# Conway Western Arterial Loop

*Bicycle and Pedestrian Design Recommendation*

*Conway Bicycle and Pedestrian Advisory Board*

July 24, 2013  
Revision 1.0

Figure 1: Recommended Intersection Design

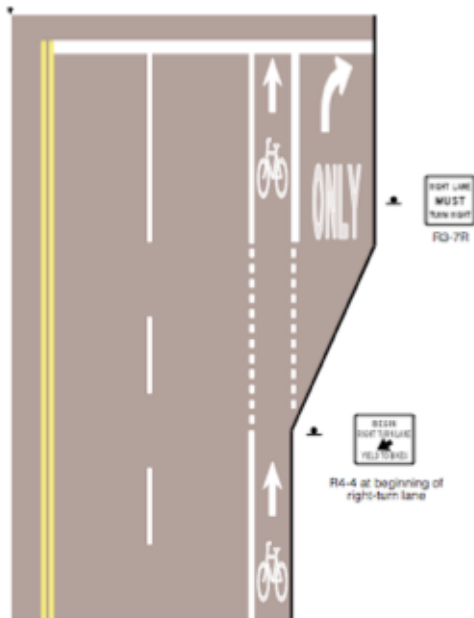
Bike lanes should be implemented the entire length of the road including on bridges and through intersections. Major intersections should include a right-turn bay to the right of the bike lane. Bike lanes should not be merged into vehicle traffic lanes as they are on other streets in Conway. See Figure 1 below for the recommended design:
